# **Staff Technical Position on Geologic Repository Operations Area Underground Facility Design -- Thermal Loads**

**U. S. Nuclear Regulatory Commission**

**Manuscript Completed: June 1992  
Date Published:**

## APPENDIX D DISPOSITION OF PUBLIC COMMENTS

Figure 1. The Logic Flow of an Acceptable Methodology for Demonstrating Compliance with 10 CFR 60.133(i)

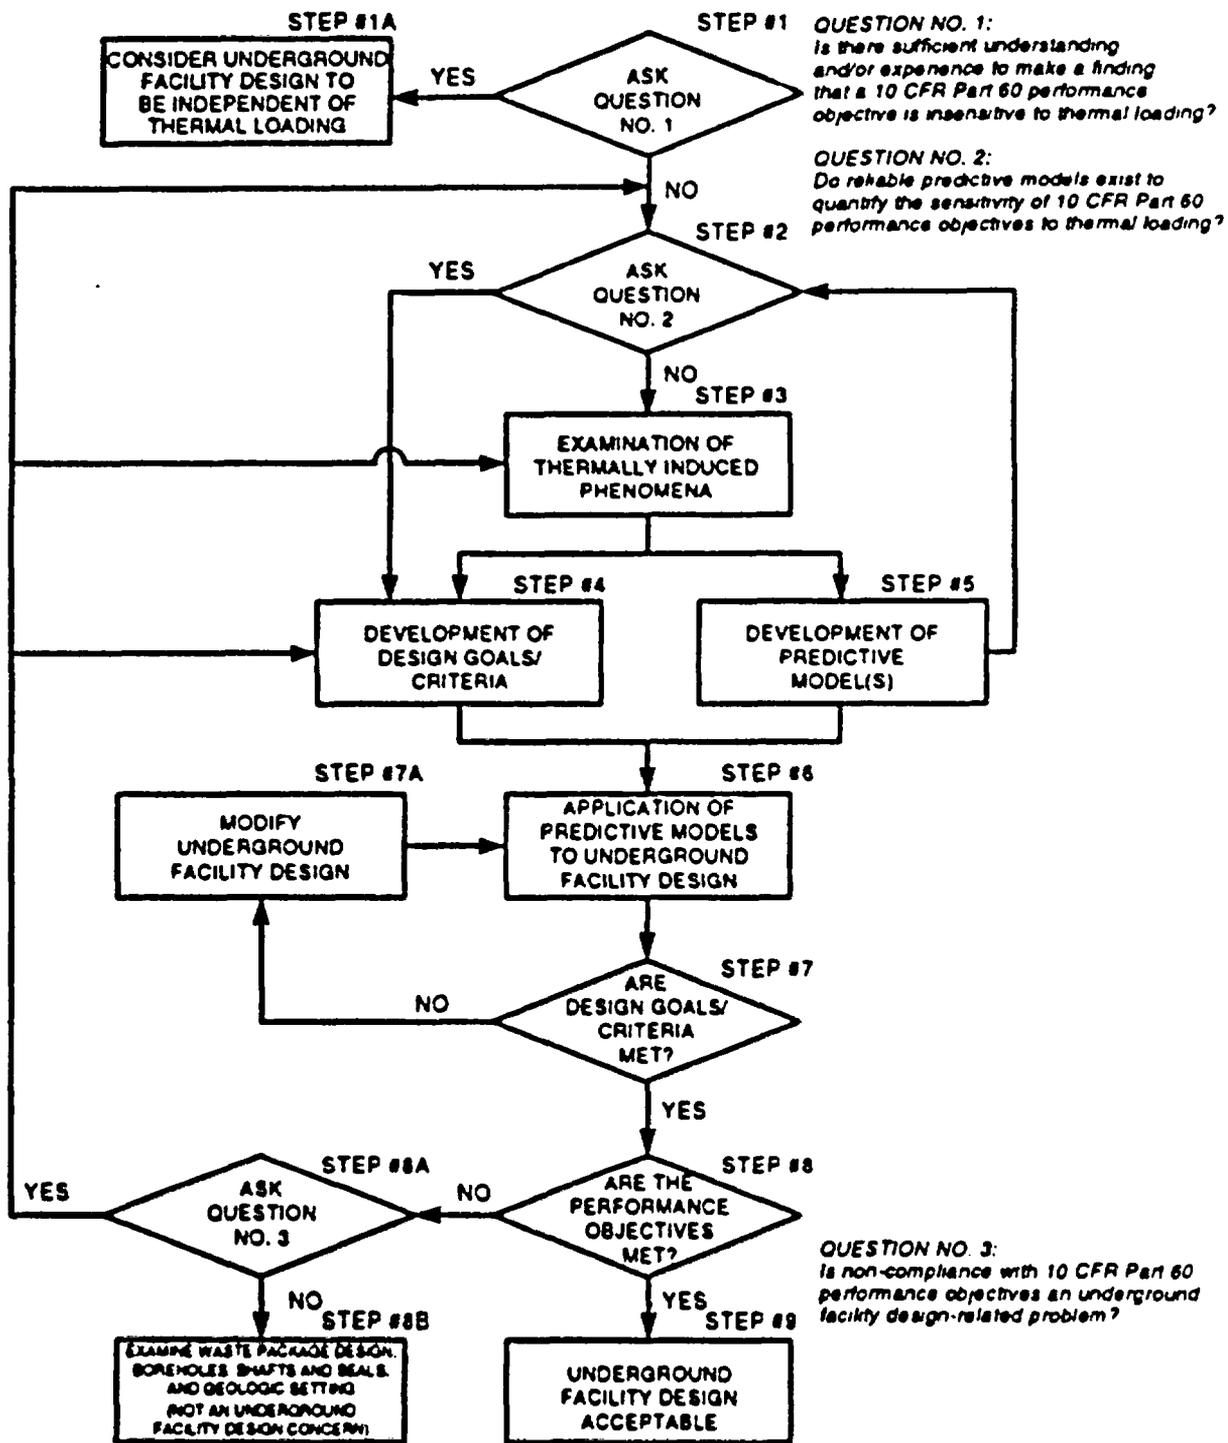
This comment is noted. However, the staff believes that the Department's recommendation would lead to an internal inconsistency that violates the overall logic detailed in Technical Position 3.1 and depicted in Figure 1. The staff's reasoning behind this position is that if there is an affirmative response to the question asked in Step No. 2, then the need to perform the analyses described in Step Nos. 3 and 5 would be obviated because existing models would already have these capabilities.

Step No. 3 needs to be clarified since it is not apparent if "defensible models" used in Step No. 3 are in fact those "existing models" that will show compliance with 10 CFR 60.133(i), as illustrated in Step No. 2A, Figure 1.

Other than the first step, Figure 1 does not indicate decision points at which the process may be terminated. Either add these decision points or do not say that they are present.

**28. Page 25, Figure 1**

However, DOE's recommendation has caused the staff to re-evaluate the logic depicted in Figure 1 and in an attempt to clarify this logic, the staff has modified the figure in the final version of the STP in two ways. First, Step No. 2A ("Use existing models to show compliance with 10 CFR 60.133(i)") in the draft version of the STP was deleted because there is no activity associated with this step *per se*. Second, the logic flow from Step No. 5 to Step No. 3 in the draft version of the STP has been changed to now indicate an iteration between Step Nos. 5 and 2. The change was made so that the approach

The staff agrees that the flow logic shown in Figure 1 for Technical Position 3.1 does not indicate any decision points for termination of the process other than the first step. Consequently, the 5th paragraph of Section 4.1 ("Discussion") has been deleted from the final version of the STP.

Regarding the first portion of this comment, DOE is referred to the last paragraph of Step No. 8, under Section 4.1 ("Discussion"), where a discussion is provided of what takes place beyond Step No. 8B. Accordingly, the staff believes that the logic flow after Step No. 8B in Figure 1 is closed.

The staff agrees with the State of Nevada comment regarding the need to revisit Step No. 2, and has modified the recommended approach accordingly. The modification involves a return from Step No. 5 to Step No. 2 in Figure 1. In addition the text for Step No. 5 has been changed in Technical Position 3.1.

Figure A1. Examples of Coupled Models.

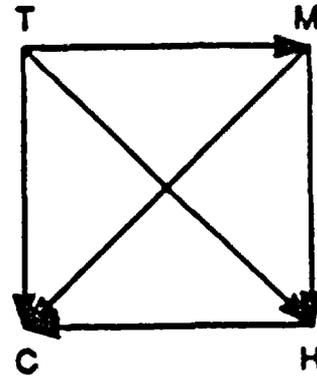
In a related matter, DOE noted that the definition of "fully-coupled" models in this STP to be "unconventional" and "ambiguous," and suggests that this term be defined in more detail. The staff agrees with this comment and has made the following revisions to the STP:

NOTE: This is a new figure. This note is to be deleted in the final version of this TP

**Figure C2. Example of an Iterative Process for the Analysis of Thermally Induced Phenomena Based on One-Way Coupling.**

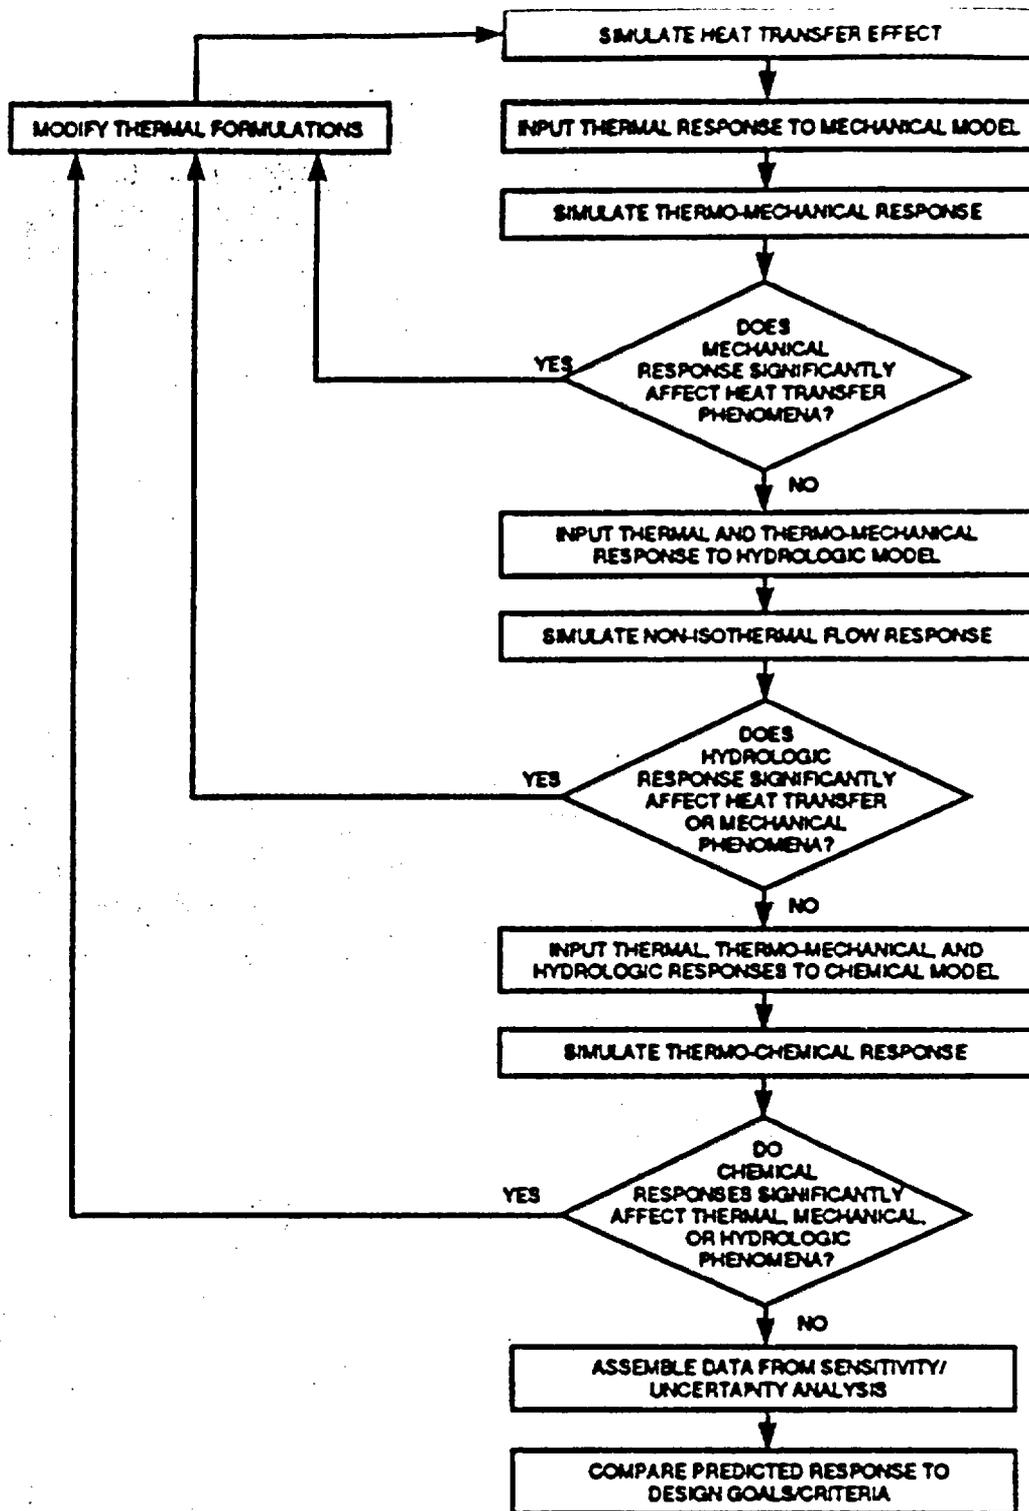
The STP states: The order in which the phenomena (e.g., thermal, mechanical, hydrological, or chemical) are analyzed in Figure C1 is shown only as an example. The responsibility to determine the most appropriate sequence of analyses rests with the licensee."

The order in which the phenomena (e.g., thermal, mechanical, hydrological, or chemical) are analyzed in Figure C2 C1 is shown only as an example. The responsibility to determine the most appropriate sequence of analysis rests with the applicant licensee. The process depicted in Figure C2 C1 is based on the need to not only provide predictions about the heat-transfer and thermally-induced effects in the host rock, surrounding strata, and groundwater system, but to provide it in a manner that allows an evaluation of the level of coupling used. ~~assumption of uncoupled processes.~~
